# Feedback on Deer Park level crossing removals

The Public Transport Users Association (PTUA) thanks the Level Crossing Removal Authority (LXRA) for the opportunity to provide feedback on the level crossing removal projects in the Deer Park area. Fitzgerald Rd, Mount Derrimut Rd, and Robinsons Rd have all seen substantial increases in road traffic in recent years, as well as substantial increases in train numbers; with the acute need to provide more public transport to the western suburbs of Melbourne, as well as to the regional centres of Geelong and Ballarat, we hope that train numbers will be increasing further in the near future. It is therefore timely that these crossings are being grade separated and that Deer Park is receiving a new elevated station.

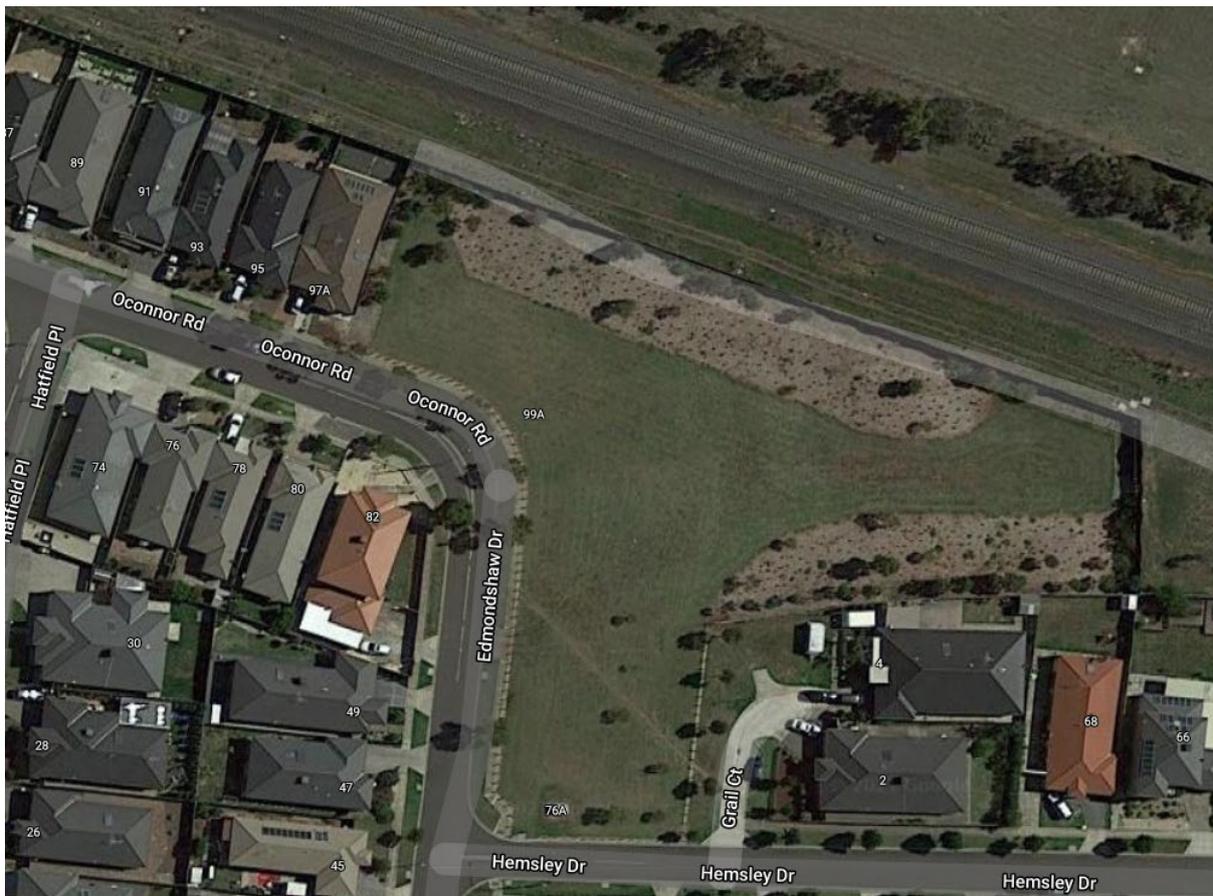
When it comes to the grassed area to the south of the new station, the proposed design has a number of crooked, meandering footpaths which do not appear to lead anywhere in particular, and others that - while straight and seemingly intended for direct walking - do not align well with likely origins or destinations of walkers. It is possible that these designs have been chosen in an attempt to provide “quirky” meandering paths for leisure walkers, but if so, this is misguided. Instead, we encourage LXRA to consider the “desire lines” between likely origins and destinations of walkers, which would provide fairly direct walking paths for people approaching the station.

A nearby example of a desire line can be found in the park at the corner of Hemsley Drive and Edmondshaw Drive, where people walking from Oconnor Road towards the station have worn a dirt path in the grass as they cut the corner.

In essence, the station’s footpath design should aim to ensure that walkers entering the precinct from Hemsley Drive, the western leg of Eagle Way, the eastern leg of Eagle Way, Tee Court, and Mount Derrimut Road itself, have as direct a path to the station as practical. (People walking from the carparks should also have a direct path, but the existing design already achieves this). One example of a design which would achieve this imperative is presented below.

Map of school catchments in the project area, via <https://www.findmyschool.vic.gov.au/>

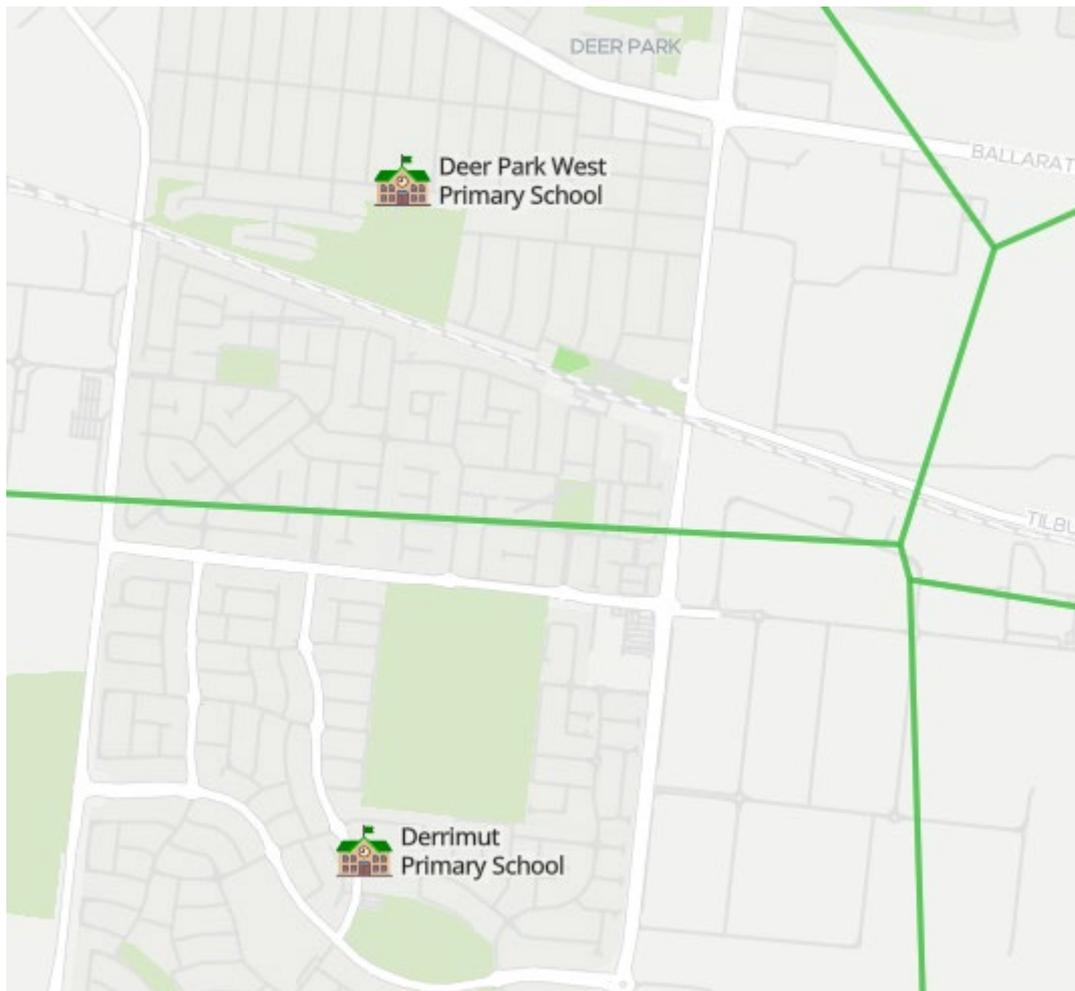
Currently, the rail corridor acts as a significant barrier to movement, dividing the Deer Park community. The distance between Mount Derrimut Road and Robinsons Road is approximately 1.6km, and no opportunities exist for pedestrians or cyclists to cross the rail corridor between these two roads.

This means that residents south of the railway line find it difficult to access sporting facilities in the Bon Thomas Reserve, Deer Park West Kindergarten, and Deer Park West Primary School by foot or by bike - despite them being very close as the crow flies. In fact, much of the area south of the railway line is in the Department of Education's catchment for Deer Park West Primary School, because it is closer as the crow flies; but using actual roads and transport links, Derrimut Primary School is likely to be closer for most students due to the indirect trip they would have to take to cross the rail corridor.

One solution to this problem would be to continue the elevated rail viaduct west approximately 400m beyond the new Deer Park Station, creating a significant amount of new, permeable green space underneath the line, which would allow for the easy creation of ground-level walking and cycling links between Edmondshaw Drive and the Bon Thomas Reserve. Again, the huge improvement to amenity created along the Djerring Trail in Melbourne's east is a good example of what could be achieved here.

However if the LXRA is unwilling to extend the viaduct this far, an alternative may be to create an elevated bike and pedestrian bridge over the ground-level rail corridor.
